GENERAL ELECTRIC

MODELS 431A, 432A, 431B, 432B, 433B AND 431BH

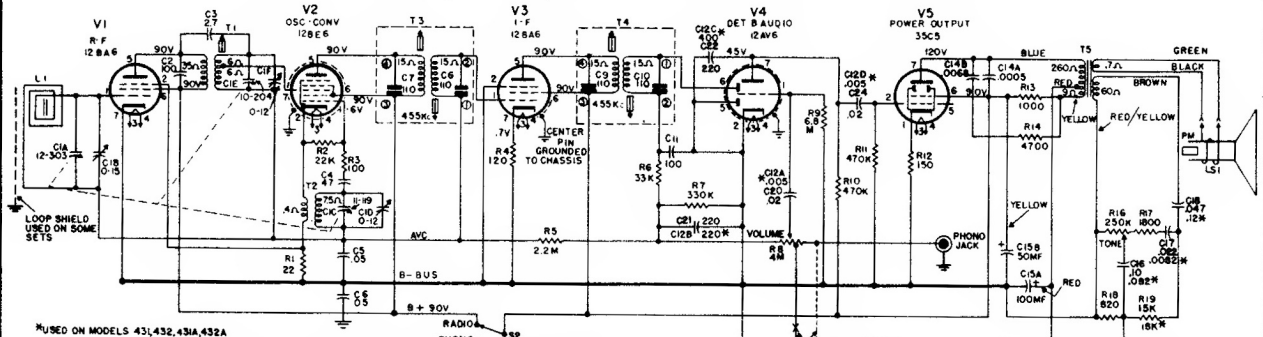
The 431 and 432 are identical to the 431A and 431B respectively, except as noted in the schematic in regard to S1 and S2. A B+ switch was added to the volume control and the former

The 431B, 432B and 433B chassis are identical. These models also employ the same arrangement of combination Radio-Phono volume control and B+ switch, and Tone control with power On-Off switch, as is used on the Models 431A and 432A. Tone control circuit components, however, were changed as shown in the schematic diagram for the 431B, 432B and 433B receivers. In addition, the ceramic couplate, C12A, B, C, D, used on the other receivers, was replaced by separate capacitors.
